# Staff Summary Report

**SUBJECT:** Hold a public meeting for a Development Plan Review for CHILDSPLAY located at 900 South Mitchell Drive. This item was continued from the June 12, 2007 public meeting.

**DPR07085** – Development Plan Review including site plan, building elevations and landscape plan.

Re: **Childsplay – Site Improvements & New Building 'E'**  
**900 South Mitchell Drive**  
**Tempe, Arizona 85281**  
**(DPA Project Number #06049.2)**

**BUILDING 'E' WEST ELEVATION**  
 SCALE: 1/8" = 1'-0"

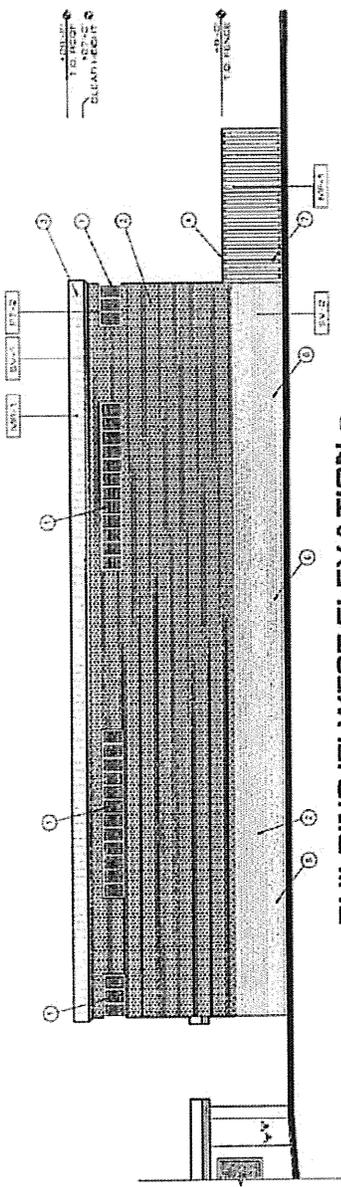
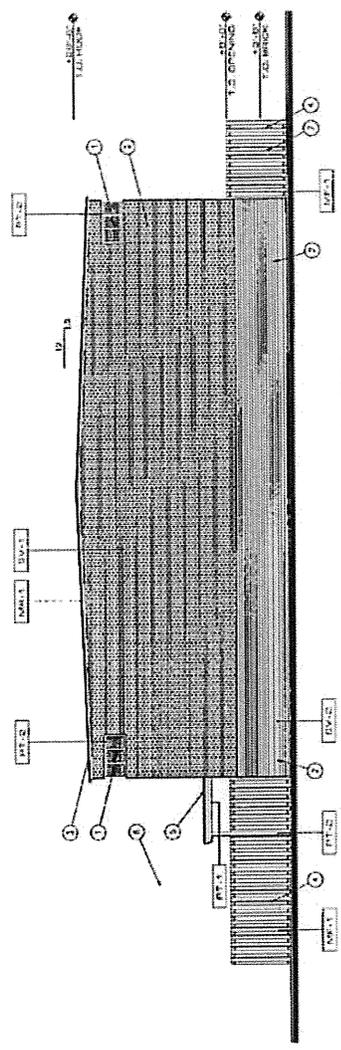
8. The new building addition shall provide on all elevations brick, matching the style of existing building facades.
9. Future proposed "artist mural" not authorized with this request. Separate review and consideration required with the Development Review Commission.

10. The applicant shall make reasonable efforts to reduce any potential noise within the new building, such as providing sound dampening walls.
11. Provide main colors and materials with a light reflectance value of 75 percent or less. Specific colors and materials exhibited on the materials sample board are approved by planning staff. Submit any additions or modifications for review during building plan check process. Planning inspection staff will field verify colors and materials during the construction phase.

12. Provide secure roof access from the interior of the building. Do not expose roof access to public view.
13. Conceal roof drainage system within the interior of the building. Minimize visible, external features, such

as overflows, and where needed design these to enhance the architecture of the building.

**BUILDING 'E' WEST ELEVATION**  
 SCALE: 1/8" = 1'-0"

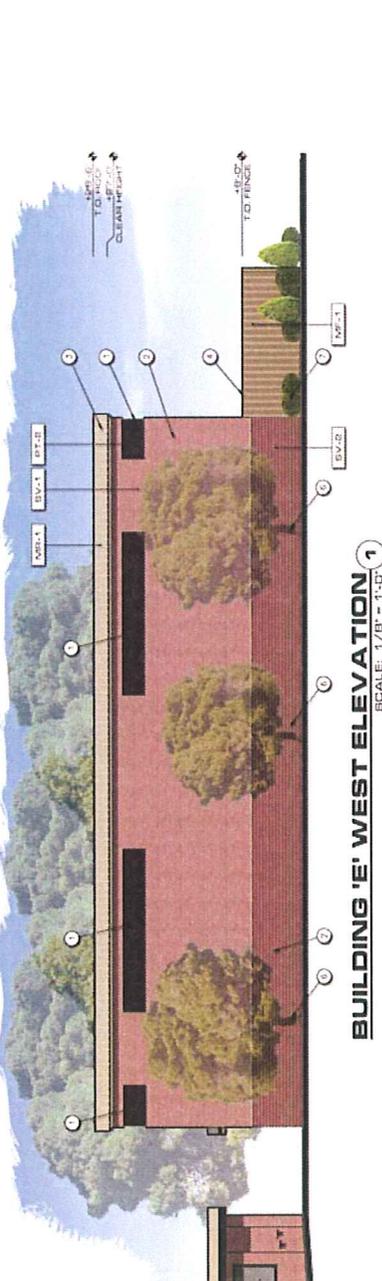
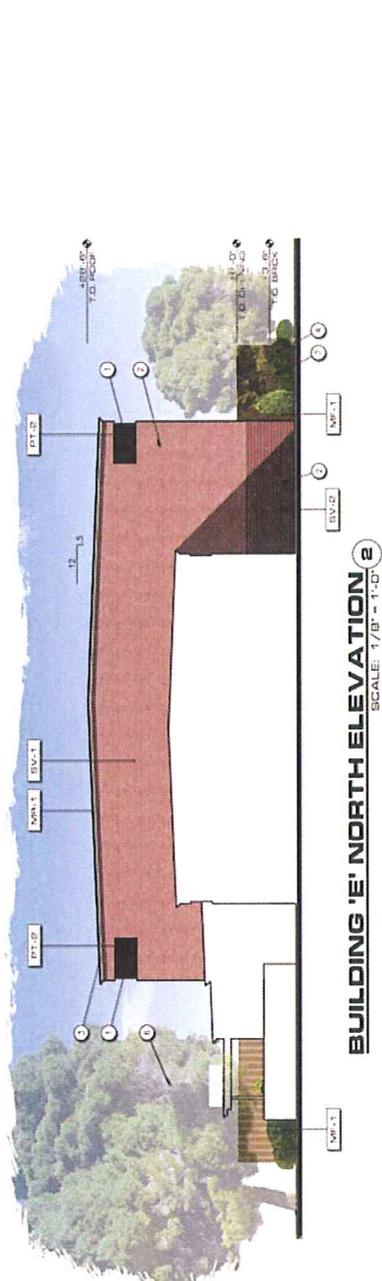
I am very supportive of Childs Play's new building design utilizing brick rather than metal for their scene production facility. We found Childs Play to be more than willing to talk with the neighbors and take to heart and act upon our concerns. I cannot imagine more fitting and desirable new neighbors than this innovative children's theatre troupe.
